Rezoning Transportation Analysis

Petition Number: 2020-039

General Location Identifier: Tax ID 12709221

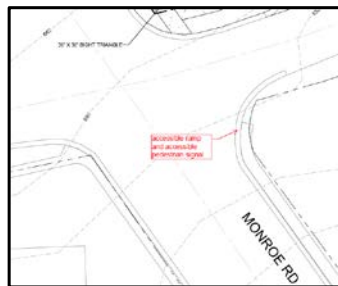
4. The petitioner should revise the site plan and conditional note(s) to commit to construct dual ramps at the corner of E 7th Street and E. 5th Street to meet the City's Charlotte WAKS Policy and PROWAG. In addition, the developer should commit to provide accessible push buttons for its corner. The site plan should label and dimension both items from the back of curb and gutter and road centerline.

5. We request for the petitioner should revise the site plan and conditional note(s) to commit to construct dual ramps at the corner of Monroe Road and E. 5th Street to meet City's Charlotte WAKS Policy and PROWAG. The site plan should label and dimension both items from the back of curb and gutter and road centerline.
